Regulation No. 46 (Devices for indirect vision)

Proposal for amendments to Regulation No. 46 (Devices for indirect vision)

**Submitted by the expert from the International Organization of Motor
Vehicle Manufacturers ***

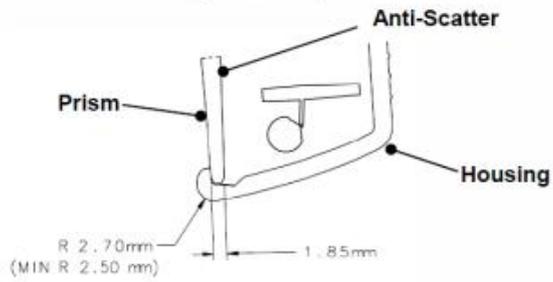
Paragraph 6.1.1.2., amend to read:

"6.1.1.2. (a) **Exterior rear-view mirrors (Class II to VII)**

The edge of the reflecting surface **shall** be enclosed in a protective housing (holder, etc.) which, on its perimeter, **shall** have a value "c" greater than or equal to 2.5 mm at all points and in all directions. If the reflecting surface projects beyond the protective housing, the radius of curvature "c" on the edge of the projecting part **shall** be not less than 2.5 mm and the reflecting surface **shall** return into the protective housing under a force of 50 N applied to the point of greatest projection, relative to the protective housing, in a horizontal direction, approximately parallel to the longitudinal median plane of the vehicle.

Standard Prismatic Mirror Construction (Section)

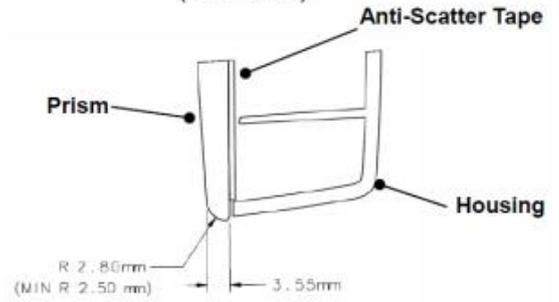
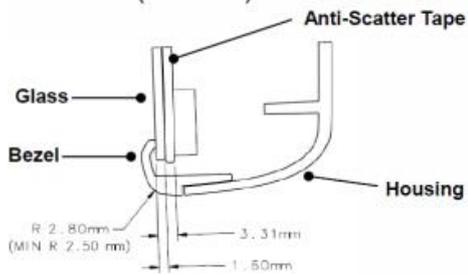
1. The evolution of technology nowadays makes possible a new generation of interior rear-view mirrors without housing or holder. This new design allows the mirror to be smaller in overall dimensions (i.e. in both width and height), leading to an improved forward Field of Vision (FOV), with no decrease in performance, while still maintaining the required rearward FOV. Unfortunately, the current text of Regulation No. 46 only allows for a mirror design that contains a housing (holder, etc.) which encloses the edge of the reflecting surface.

2. Compared to standard prisms and electro-chromatic glasses, the frameless mirror technology improves the overall glass strength and does not affect mirror reflectivity, and the lack of frame around the glass has no influence on the performance for the driver. The edge of a frameless mirror is rendered opaque by abrasion of the projecting part; only the plane mirror surface does reflect light.
